Memorandum

SUBJECT: **APPLE CROSSING REGULATING PLAN WITH MAJOR WARRANTS
(CPA2016-3)**

REGULATING PLAN
PROJECT # CPA 2016-3
APPLE'S CROSSING ADDITION
182 RESIDENTIAL LOTS, 17 OPEN SPACE LOTS
1 COMMERCIAL LOT
38,507 GROSS ACRES
37.867 NET ACRES

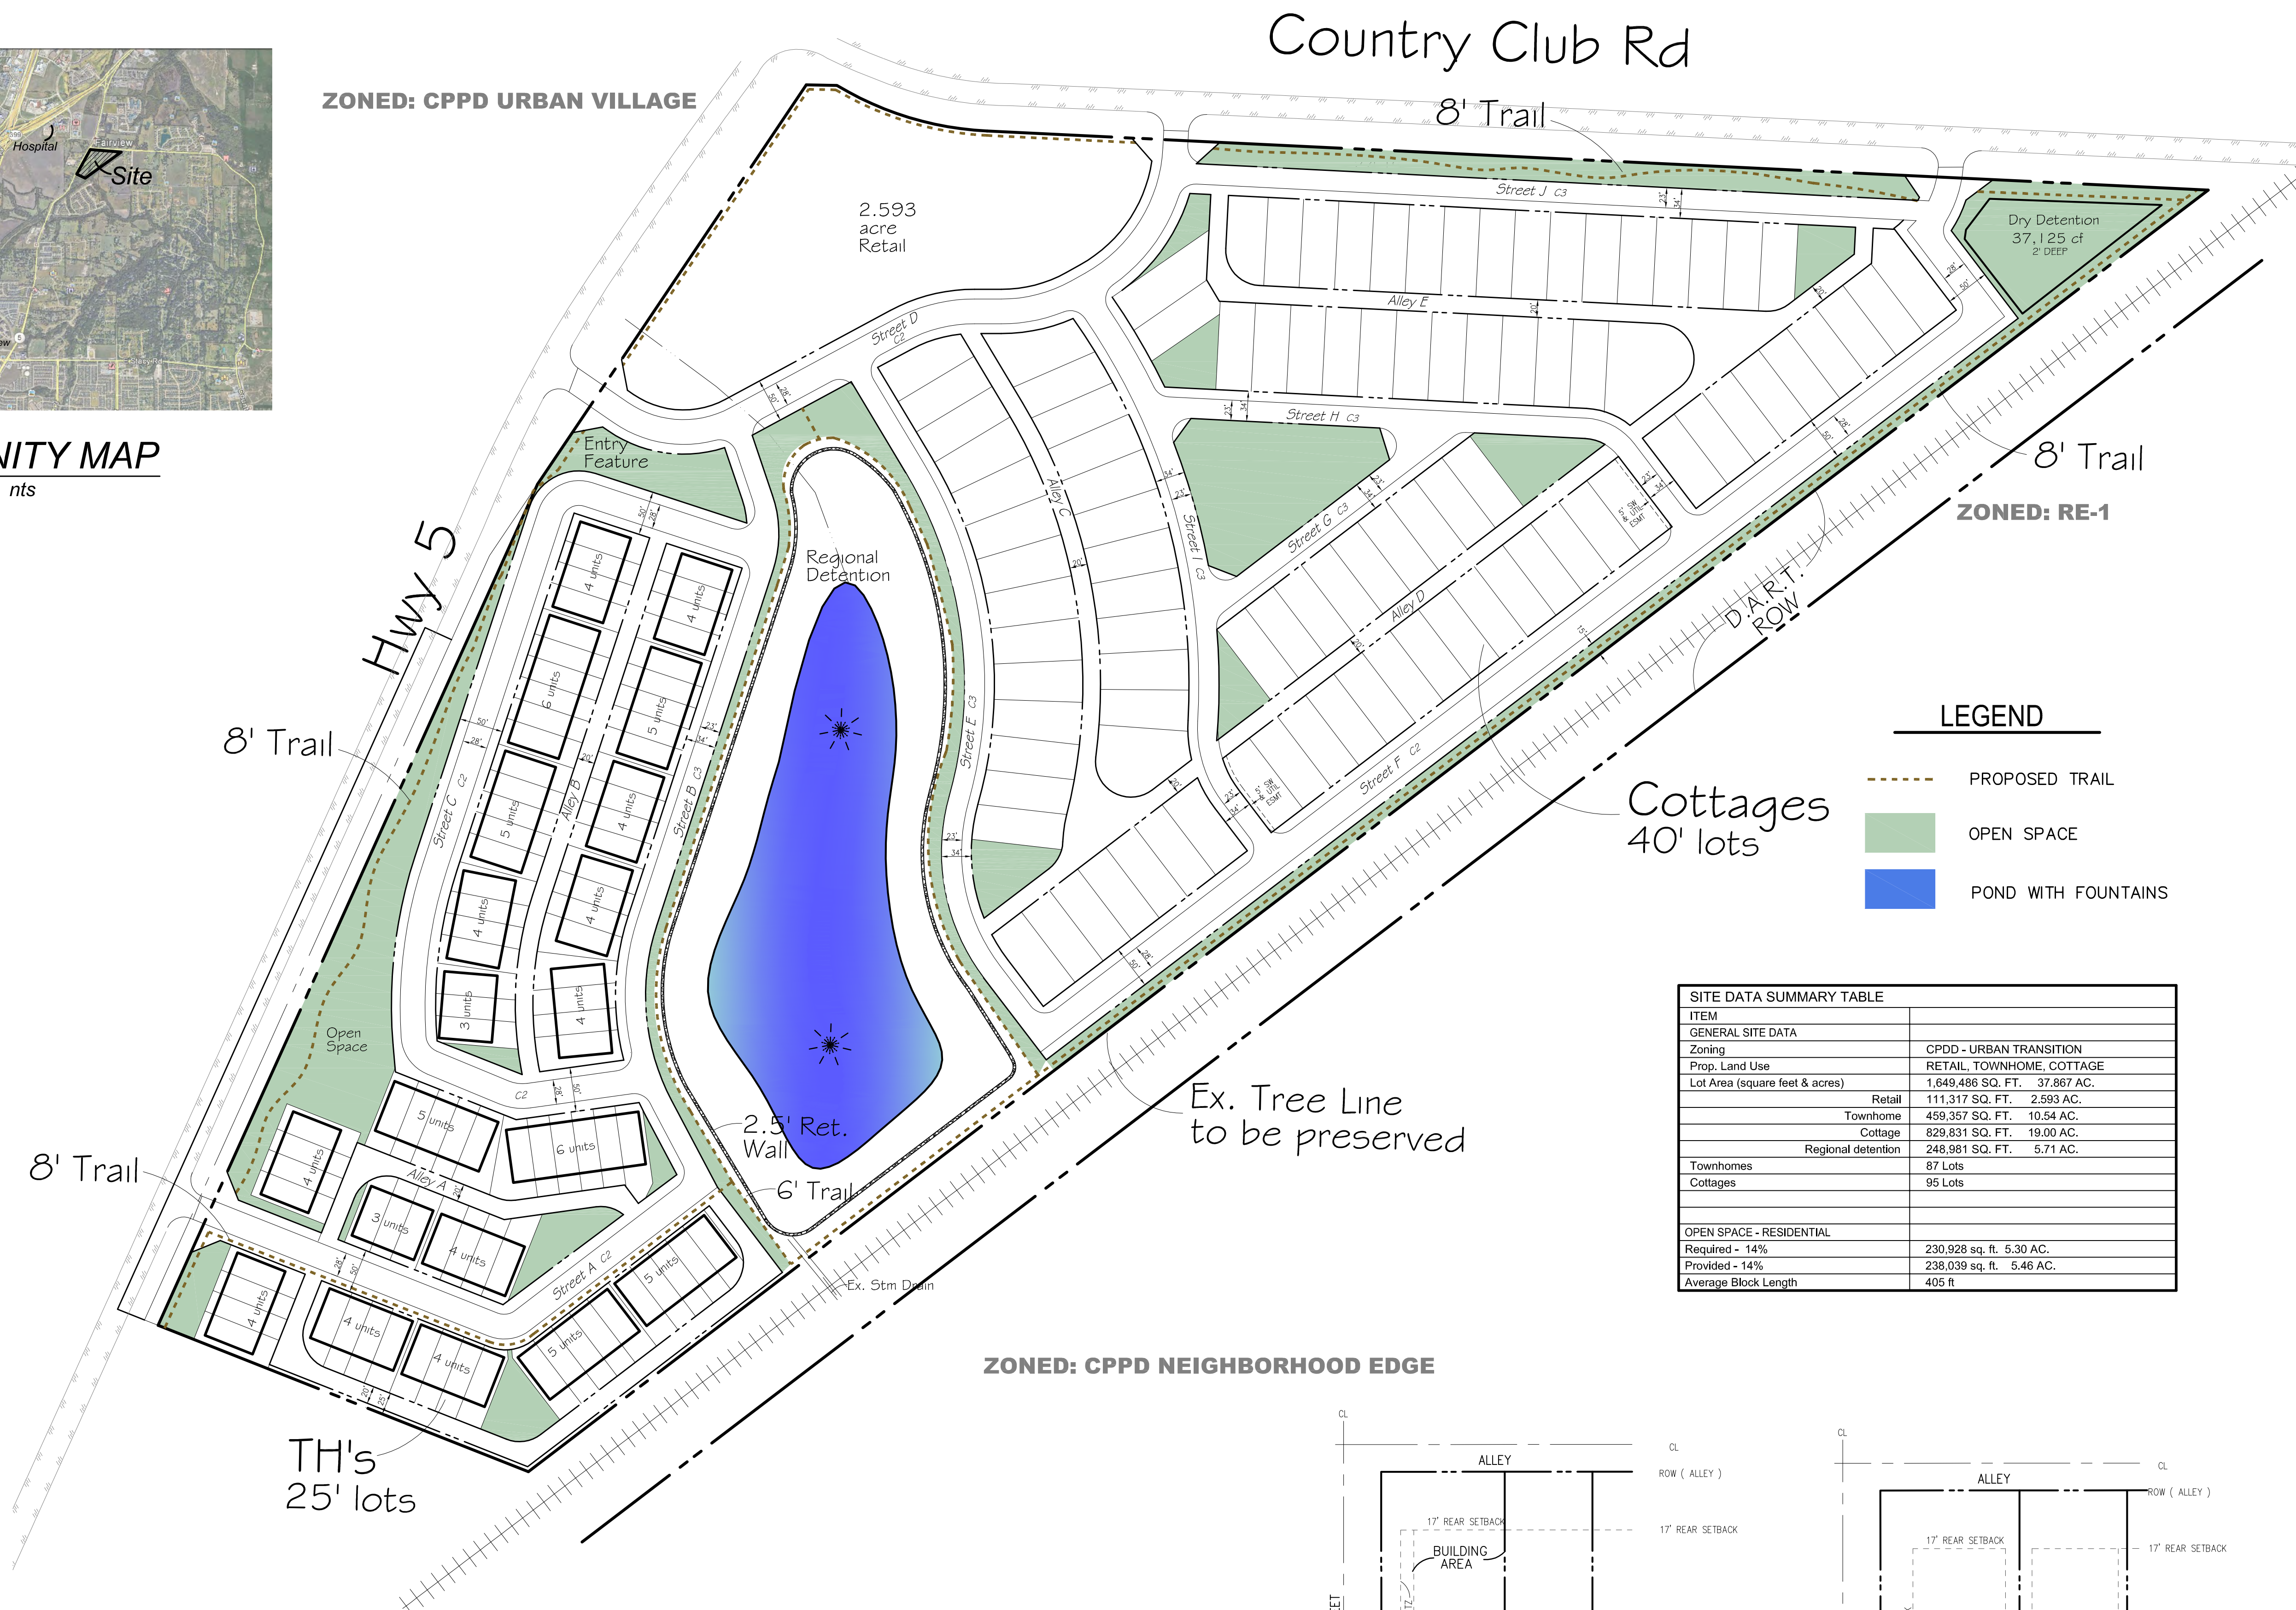
With the redesign of the townhome area, as discussed at the PZ meeting in April, the route for the trail along the eastern property line has been changed. The regulating plan reflects the new trail alignment along the southern side of proposed Street A that connects the trail along Highway 5 to the trail along the railroad tracks.

Item	Requirement	Proposed	Applicant Justification	Staff Comments
+	Permit front entry garage TH lots	Min 60’ lot width	As shown: 32 TH units with min. 25’ lot width	Permits direct access to trail; eliminates adjacency issues with main entry	The proposed front entry TH, are located along the southern border and adjacent to the main entry from HWY 5. For the southern units, the design allows for a calmer homeowner and safer pedestrian experience on the trail. Along the main entry, due to area, the addition of an alley would detract from the ability to provide an attractive entryway feature and landscaping. Should front entry

warrant request be accepted, the private driveway should be treated within stain, color, and/or patterned to reduce the visual impacts of the concrete.
2	BTZ for front entry garages	4' - 10'	20 setback	Provides adequate driveway space	In order to provide adequate space within the driveway and to not block the sidewalk, the buildings must be setback a minimum of 20.'
3	Front entry garage setbacks	20' behind front corner	Zero	Not possible to setback two-car garage behind front corner of home with 25' townhomes	Since the code only permits front entry garage on single family detached homes with 60' of lot width, the parking standards requires the garage to be located at minimum 20' behind the front corner of the home. In this case, with 25' wide TH lots, the limited amount of space prohibits the garage to be setback 20.'
4	Front entry garage door design	Two (2) single garage doors	Double wide door	Limits vehicle size; results in more on-street/driveway parking	The code requires two (2) single garage doors when front entry are permits. Again, since the code only permits front entry on lots with a minimum of 60' of frontage, the size of the TH lots creates an architectural and design problem. Should the front entry TH be acceptable, material and design standards should be required for the garage doors.

5	Retail lot BTZ along Street D	18' - 26'	Zero	Buildings front HWY 5 and Country Club; thus parking will be between buildings and Street D.	Due to the size of the retail lot and it being surrounded on all sides by streets, the code would require a BTZ from all streets. In this case, to meet the intent of the code, shopfront buildings would be built along HWY 5 and Country Club, leaving parking to be "behind" those building.
6	Block length	500, 720' capped	820 max	Block length due to streets along detention area; have access to internal trail	The plan meets the 500' average block length. Larger block length is due to the size and location of the regional detention pond. As shown, the plan reflects an internal trail surrounding the pond, thus provides adequate pedestrian

circulation throughout the development.
7	Alley Trees	One (1) 3-inch tree planted within 10 feet of rear property line per lot	Not require tree, provide enhanced landscaping	Not enough space to plant trees within rear setbacks (BTZ); space, utilities, and driveway conflicts.	Until detailed development plans are produced, how much space is available to plant trees within the rear yard setback (BTZ) is unknown. Often, rear yards, in an urban style developments are encumbered with utilities, driveway for garages, and easements that prevent adequate area for trees. This warrant will give the developers the flexibility on their landscaping design adjacent to the allies.
8	Facade Material change	Material changes permitted at inside corners or 20' back from front facade	Meet standard on "public" facades. Interior facades: inside corners or 4' from front facade	20-foot returns are not visible given 10' building separation on internal facades	The intent of this provision is to ensure visual aesthetics on side facades. In this case, due to the 10-foot of separation between buildings, the internal facades will not be visible, especially once on-site landscaping is planted.

RECOMMENDATION: Staff recommends **APPROVAL** of the subject major warrants and the preliminary plat.
